# Access Compliance Report

## Public Rights-of-Way

### (Curb Ramps)

Intersection ID: 42369	Main Street: BENTGRASS_RUN_DR	Cross Street: LYLETON_LN	Location: S
ADA ID: 7DECA5B3452F	Ramp Type: PerpDiag	Initial Pass/Fail: Pass	Overall Compliance: No
Severity Score: 10			
Codes/Mitigation Info/Possible Solution		Field Measurements/Component Compliance

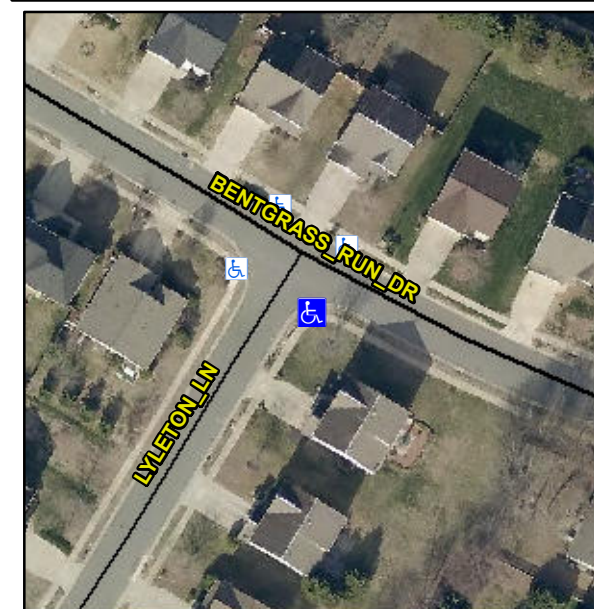
**Not Found, R304.2.1, R305**

Compliance	Description	Data	Compliance	Description	Data
N/A	Ramp Length (in)	41.0	Yes	Ramp Slope (%)	5.9
Yes	Ramp Width (in)	96.0	Yes	Ramp XSlope (%)	1.9
N/A	Flare Type LT	Sloped	N/A	Flare Type RT	N/A
N/A	Flare Slope LT (%)	7.9	N/A	Flare Slope RT (%)	4.2
N/A	Flare Traversable LT?	No	N/A	Flare Traversable RT?	No
No	Landing Length (in)	46.5	No	DWS Provided?	No
Yes	Landing Width (in)	92.0	N/A	DWS Contrast?	No
Yes	Landing Slope (%)	0.2	N/A	DWS Length (in)	N/A
Yes	Landing X Slope (%)	0.3	N/A	DWS Full Width?	No
N/A	Landing Curb? (Y/N)	No	N/A	DWS Offset (in)	N/A
N/A	Shared Landing?	No			
Yes	Gutter Ponding?	No	Yes	Gutter Slope (%)	1.7
Yes	Gutter Lip Ht (in)	0.0	Yes	Gutter X Slope (%)	1.1
N/A	Painted X Walk1?	No	N/A	Painted X Walk2?	No
	X Walk 1 Direction	To NE		X Walk 2 Direction	To NW
N/A	X Walk 1 Width (in)	N/A	N/A	X Walk 2 Width (in)	N/A
	X Walk 1 Slope (%)	0.5		X Walk 2 Slope (%)	0.4
	X Walk 1 X Slope (%)	0.4		X Walk 2 X Slope (%)	1.0

N/A	Ramp inside XWalk1?	N/A	N/A	Ramp inside XWalk2?	N/A
	Road Slope (%)	0.8	N/A	Clear Space?	Yes
	Road X Slope (%)	0.5	N/A	Clear Space to XWalk (in)	N/A
Yes	Any Obstructions?	No	Yes	Storm Grate/Utility Hazard?	No
	Obstruction Type			Storm Grate/Utility Type	
		N/A			N/A
			Yes	Surface Condition? (G/P)	Good

**Remove & Replace Curb Ramp With Two New Directional Ramps or Equivalent.**
